COPPER CHASE AT STERLING RANCH PUD PRELIMINARY PLAN

LETTER OF INTENT

FEBRUARY, 2019

Figure 1. Sidewalk Connectivity

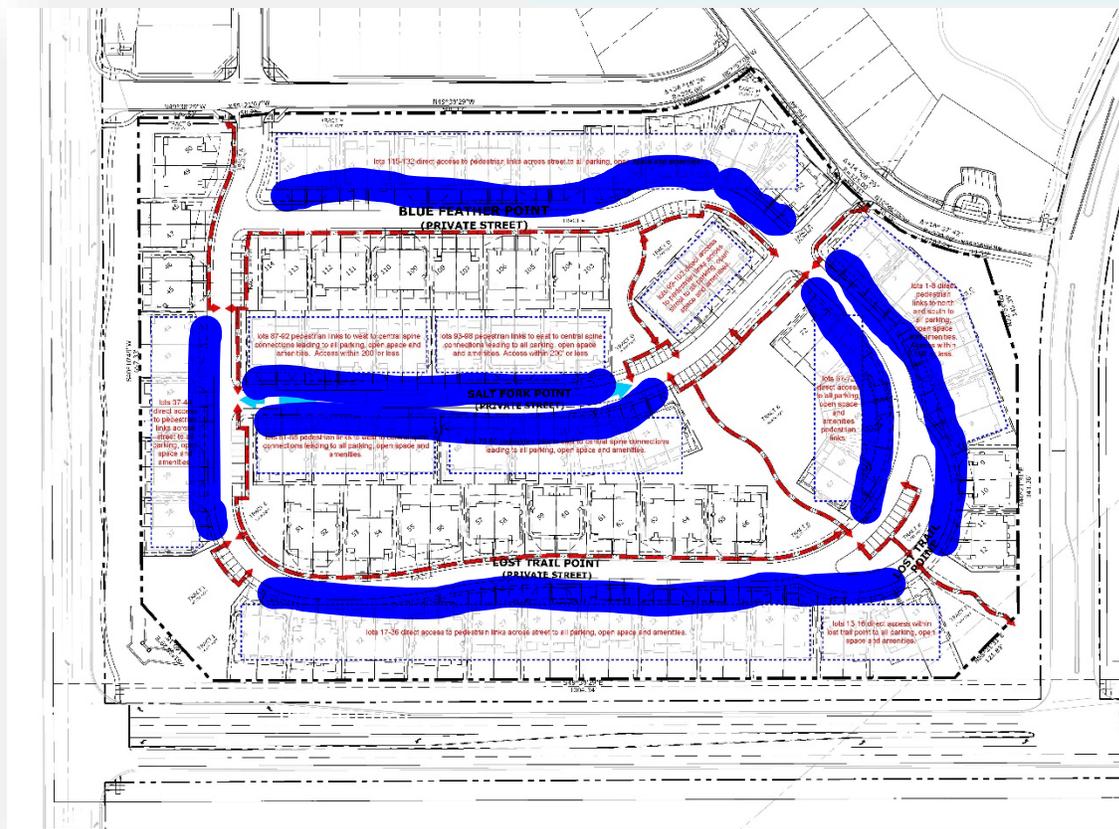
Highlighted areas don't appear to provide pedestrian connectivity.
